Product Change Notification (PCN)

Connector - Sleeves

Change Notification # PCN200906001

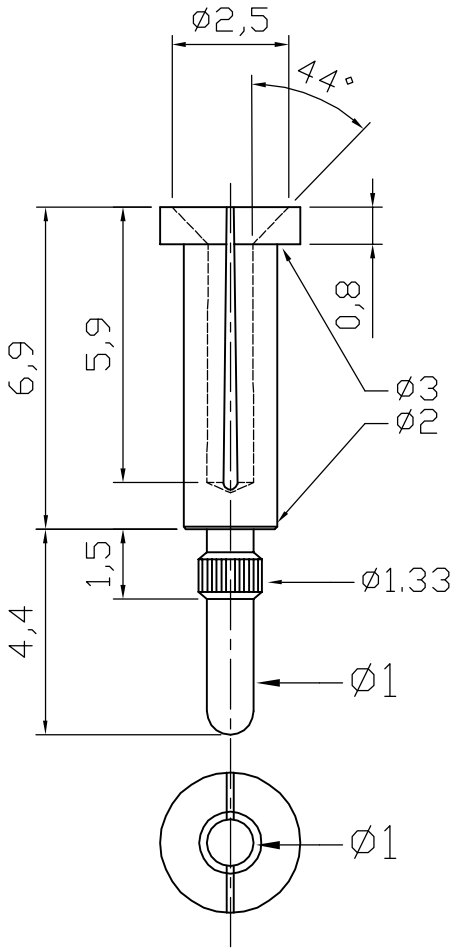
Change Description :
Change of product design of bevel from 30° to 44°
Change of order code from AP 90 to AP 90N
